NIAGARA MOHAWK POWER CORPORATION

LICENSE NO. DPR-63

DOCKET NO. 50-220

Proposed Changes to Technical Specifications (Appendix A)

FIGURE 6.2-2
NINE MILE POINT NUCLEAR SITE ORGANIZATION

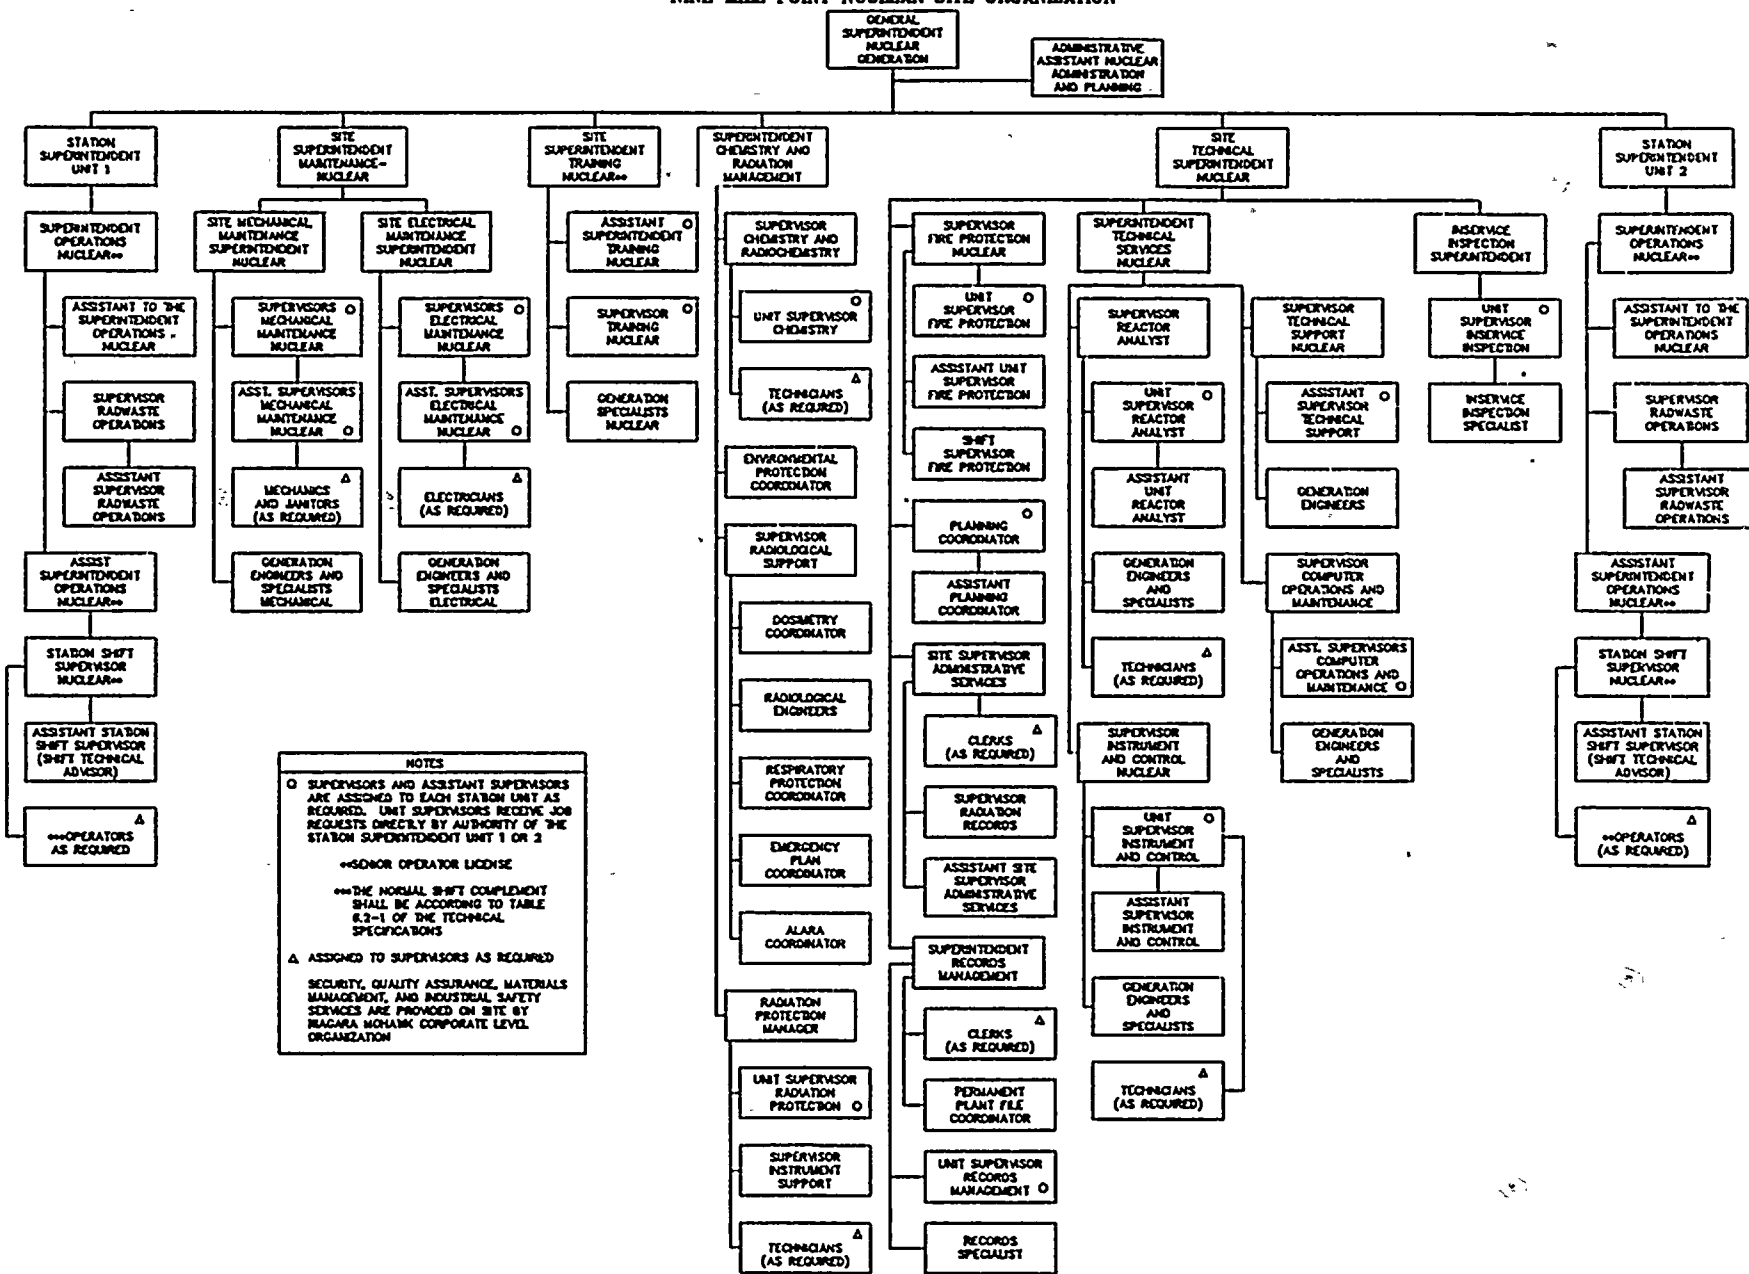
The proposed amendment to Figure 6.2-2 of the Technical Specifications reflects the combined nuclear site organization for Nine Mile Point Unit 1 and Unit 2. The change also represents a restructuring of the Chemistry and Radiation Management Organization. The position of Supervisor Chemistry and Radiation Protection has been divided into two separate positions. The newly created positions are Supervisor Chemistry and Radiochemistry, and Radiation Protection Manager. This change was made to improve the efficiency and effectiveness of the Chemistry and Radiation Management Organization.
